Work Order ID 100019

Item Name: Crosstube Aft

DRAWING NO. D206-667-243	TITLE CROSSTUBE ASS'Y (206L HIGH AFT)	REV. C	DART AEROSPACE LTD ENGINEERING ORDER		D.E.O. NO D206-667-243-C-1	SHEET NO SHEET 1 OF 1	SCALE NTS
DRAWN 97	CHECKED ASS	MFG. APPR. RB	APPROVED MP		DE APPR. #		
DATE 11.07.15	DATE 11.07.20	DATE 11.07.21	DATE 11/07/21		DATE 11.07.21

A	NEW ISSUE	CP	11.07.15
REV.	DESCRIPTION	BY	DATE
DESIGN		<b>DART AEROSPACE LTD</b> HAWKESBURY, ONTARIO, CANADA	
DRAWN			
CHECKED	ASS	DRAWING NO.	REV. A
MFG. APPR.	N/A	DSI 9565	SHEET 1 OF 1
APPROVED		TITLE	SCALE
DE APPR.		SUPPORT INSTALLATION CHANGE	NTS
DATE	11.07.15	COPYRIGHT © 2011 BY DART AEROSPACE LTD <small>THIS DOCUMENT IS PRIVATE AND CONFIDENTIAL AND IS SUPPLIED ON THE EXPRESS CONDITION THAT IT IS NOT TO BE USED FOR ANY PURPOSE OR COPIED OR COMMUNICATED TO ANY OTHER PERSON WITHOUT WRITTEN PERMISSION FROM DART AEROSPACE LTD.</small>

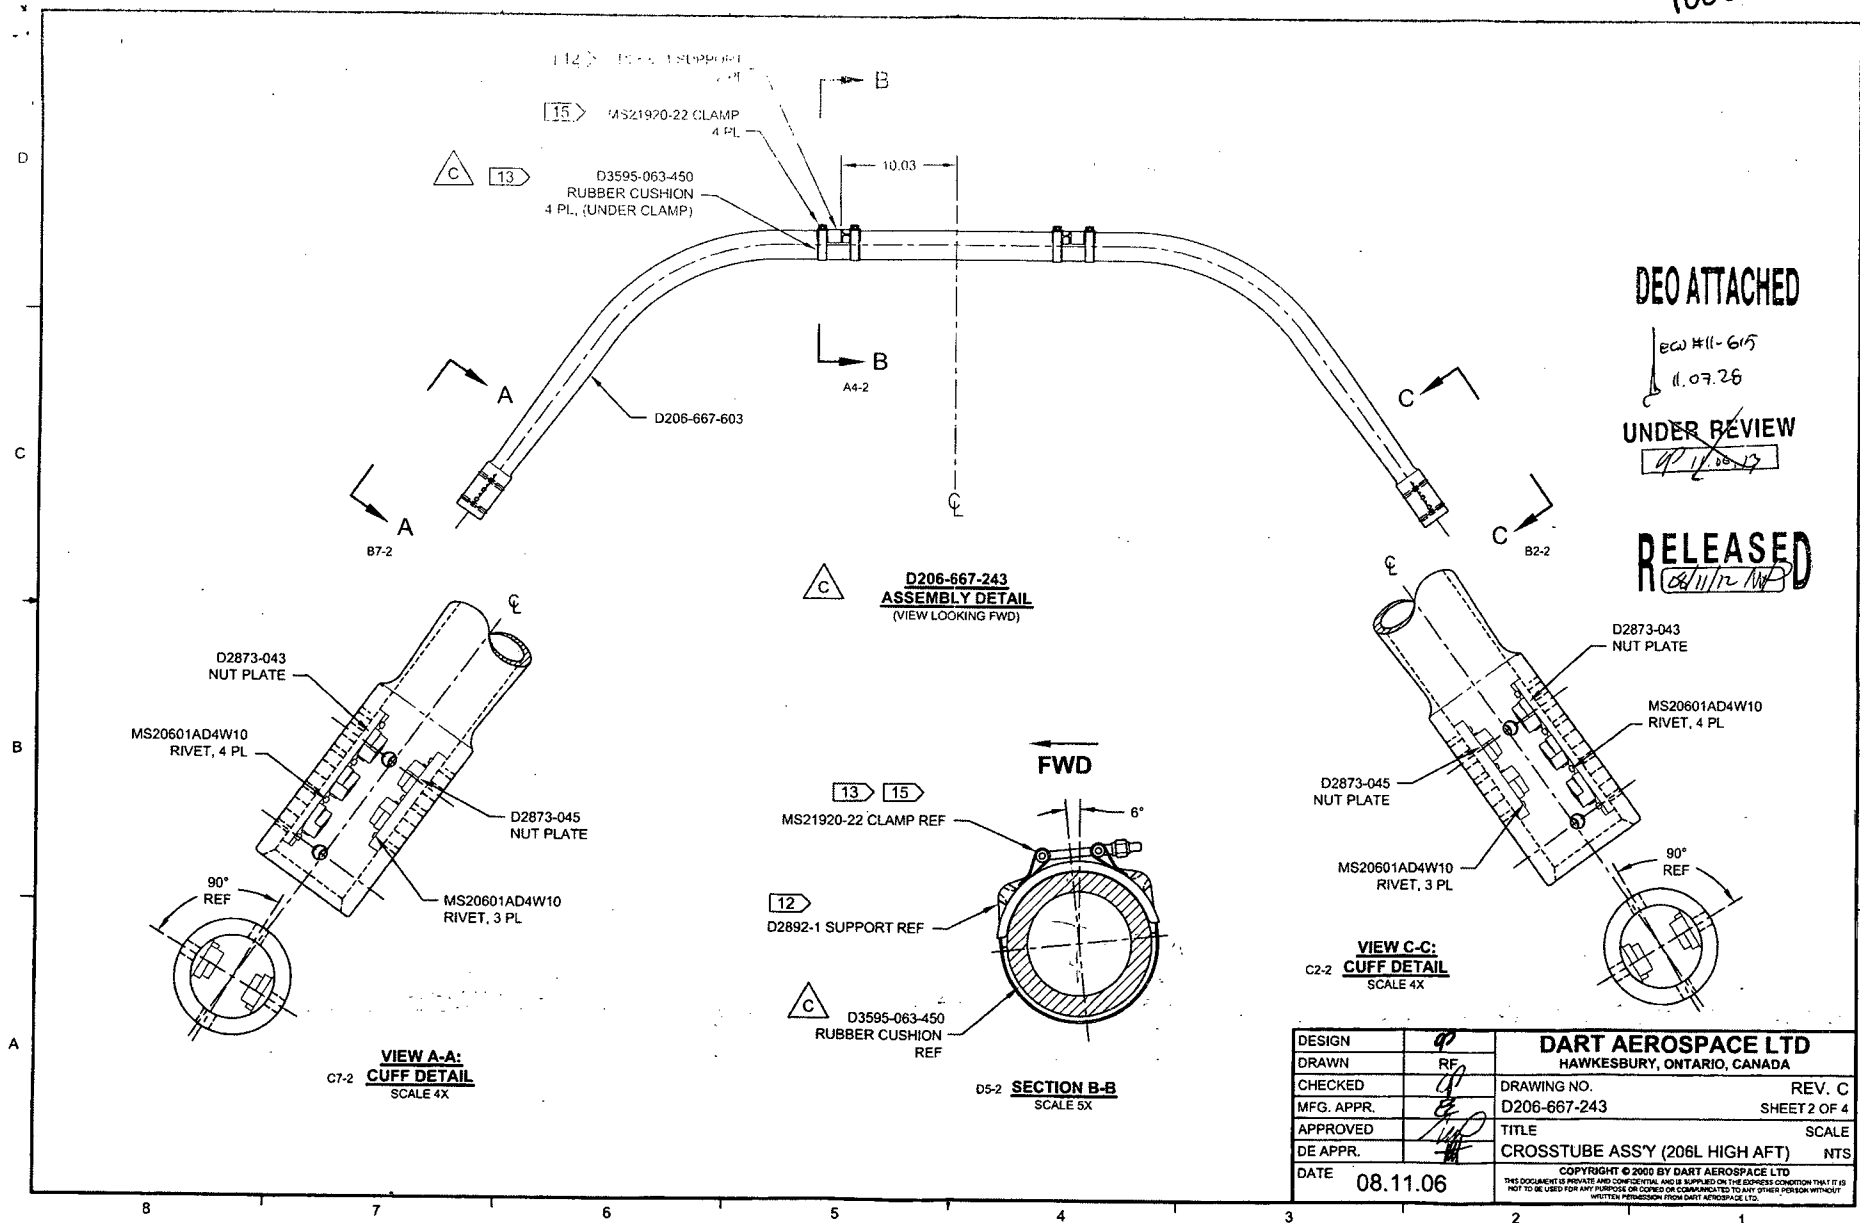
C	REVISE GENERAL NOTES/PART LIST (ZN D7-1); REORGANIZED VIEWS AND REFORMATTED DRAWING TO CURRENT STANDARDS. D3595-063-450 WAS D2856-400-773 (ZN D6-2 & A5-2); REMOVED REF. & ADD TOLERANCES (ZN 4-3, C5-3, D3-3); RELOCATED FLAG #6 (ZN A8-3) PER NCR 210; MOVED TURNING DETAIL & UPDATED TOLERANCE TO SHEET 4.	RF	08.11.06
B	ADD HOLES AND NUT PLATES FOR COMPATABILITY WITH BHT/AA SKUDTUBES	PH	05.07.26
A	NEW ISSUE	CP	00.11.17
REV.	DESCRIPTION	BY	DATE
DESIGN	RF	DART AEROSPACE LTD HAWKESBURY, ONTARIO, CANADA	
DRAWN	RF	DRAWING NO. D206-667-243	REV. C SHEET 1 OF 4
CHECKED	RF	TITLE CROSSTUBE ASSY (206L HIGH AFT)	SCALE NTS
MFG. APPR.	RF	DATE 08.11.06	
APPROVED	RF	COPYRIGHT © 2000 BY DART AEROSPACE LTD THIS DOCUMENT IS PRIVATE AND CONFIDENTIAL, AND IS SUPPLIED ON THE EXPRESS UNDERSTANDING THAT IT IS NOT TO BE USED FOR ANY PURPOSE OR COPIED OR COMMUNICATED TO ANY OTHER PERSON WITHOUT WRITTEN PERMISSION FROM DART AEROSPACE LTD.

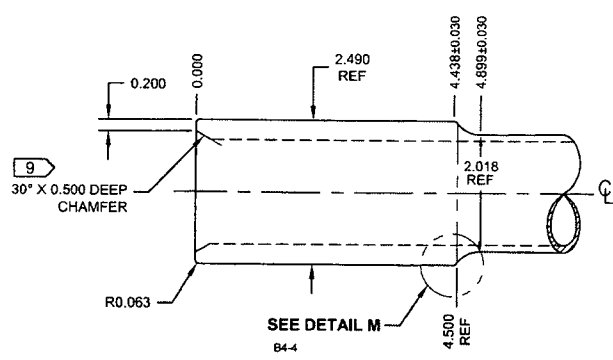
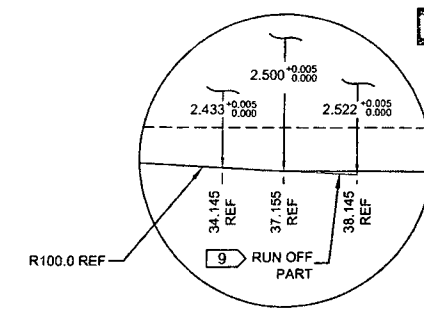
**C TURNING DETAIL**

**C7-4 DETAIL L: CROSSTUBE CUFF**  
NOT TO SCALE

**B6-4 DETAIL M: CUFF TRANSITION**  
NOT TO SCALE
